From: [Stephen Ubl](#)
To: [Marcia Moermond](#)
Cc: [Nathan Bruhn](#)
Subject: FW: 733 Fairview Ave. N.
Date: Monday, March 11, 2024 1:04:54 PM
Attachments: [image005.png](#)
[image006.png](#)
[image007.png](#)
[image008.png](#)
[image009.png](#)
[image010.png](#)

I have been told that you are engaged in a project at 733 Fairview Ave. N., a building identified as a Vacant Building Category III. If you have questions regarding Plan Review, Permitting, Inspections, or Appeals, please reach out to me and I can see what I can do to move this project along.

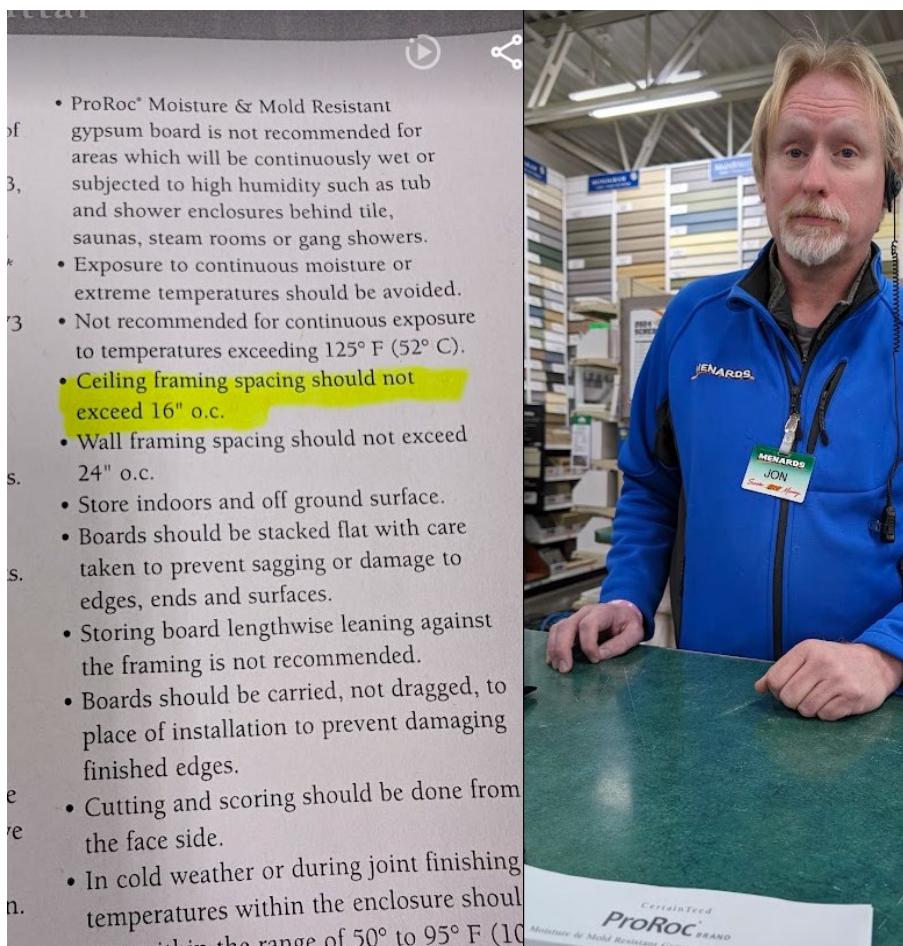
Tuesday, after our meeting, I went to Menards. I eventually was able to speak with Jon, in the building center, who is familiar with my situation. I asked him to provide me with the literature on the manufacturer's installation instructions for the moisture-mold-resistant sheetrock to determine whether what I did in my home complied with the manufacturer's installation recommendations. I asked him specifically whether the moisture & mold resistance gypsum board he sold me from Menards to install on many of the walls and ceilings, per the manufacturer's instructions, called for it to be installed on 16" on center or whether it required a lesser distance. Without saying a word, Jon got on his screen, printed, and with his yellow highlighter, marked the following and slid the paper over to me: **"Ceiling framing spacing**

should not exceed 16" o.c." Based on the above, I complied with the manufacturer's gypsum board moisture-mold-resistant installation recommendations, Stephen.

733 Basement

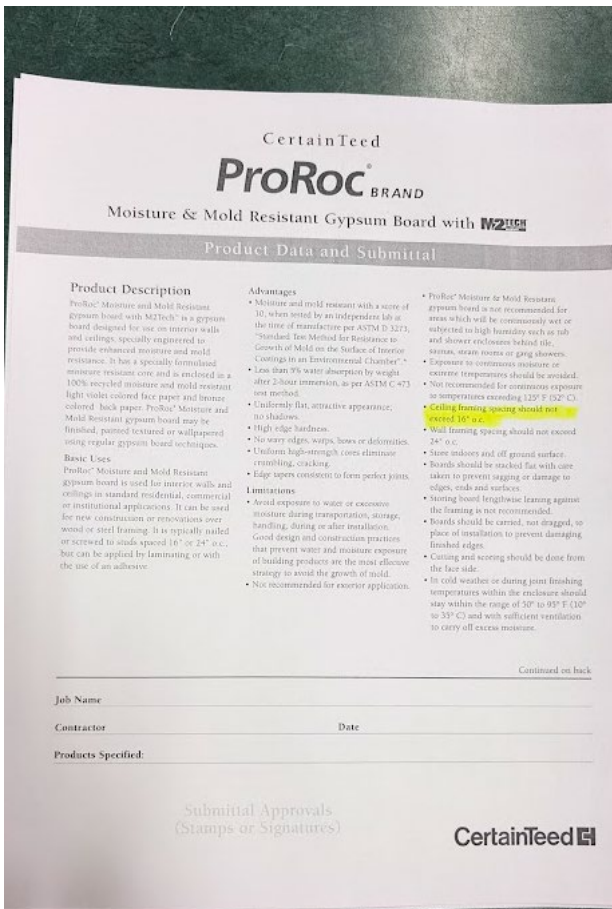
Next, I am sharing with you a series of photos that illustrate the 3 bathrooms in the 733 Fairview Ave. N. home: 1) Main Floor bathroom; 2) Upstairs bathroom; and, 3) Basement bathroom. As I discussed with you, all three bathrooms are entirely done with cement board. In fact, there are additional areas in the home that have cement boards as well. For instance, there is cement board in the Main Floor front entryway, in the Main living room, in the kitchen, in the utility room, in the upstairs landing area, and covering all the flooring areas in the Upstairs and the Main floor.
